Alexa motor - does it work?
PROPOSED FIRST FLOOR PLAN

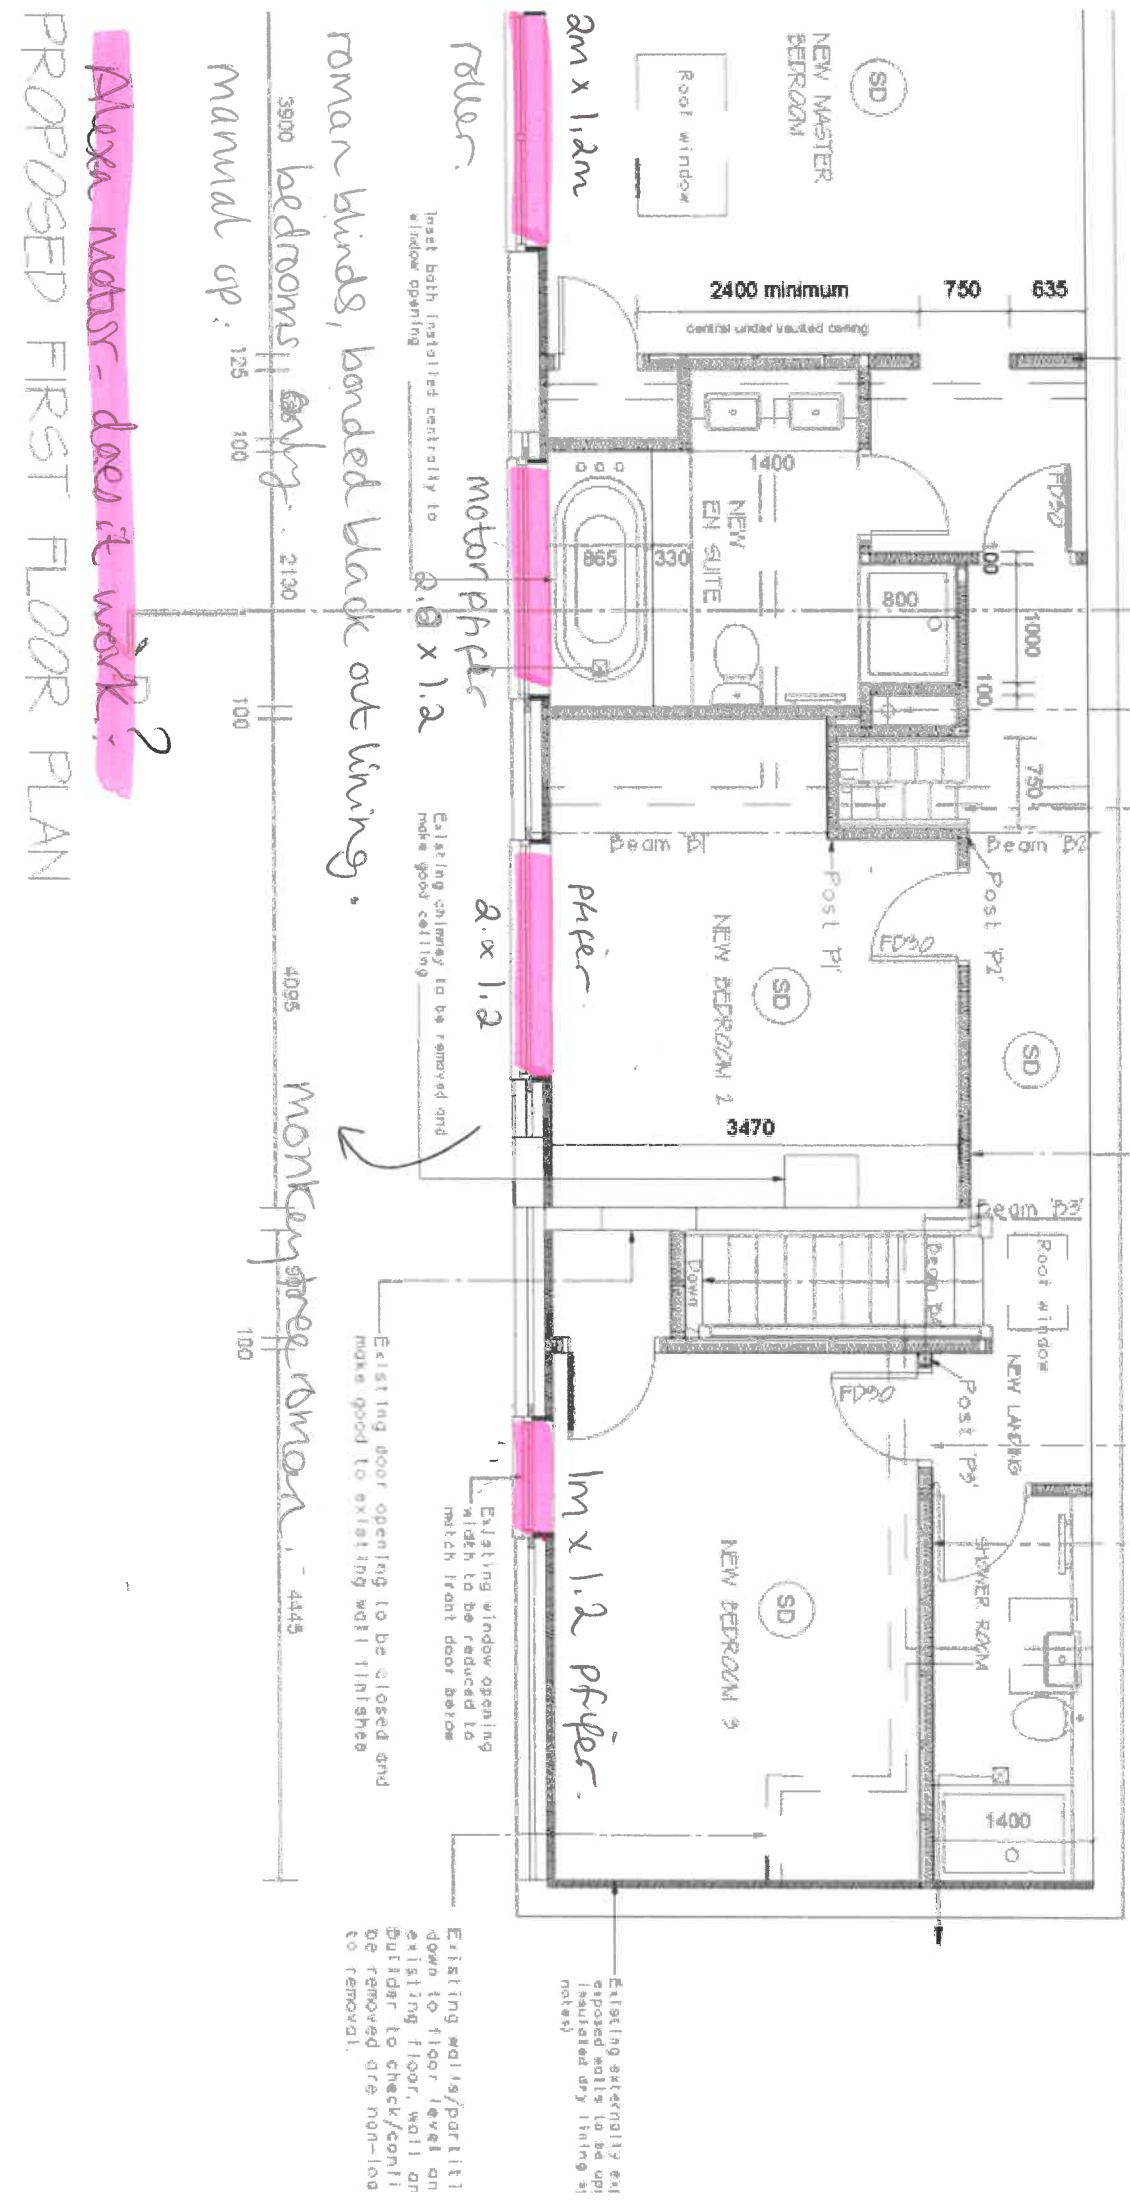
roman blinds, bonded black out lining.
3900 bedrooms
Manual op. 125 100 2130 100

4095 monkey room
100 4445
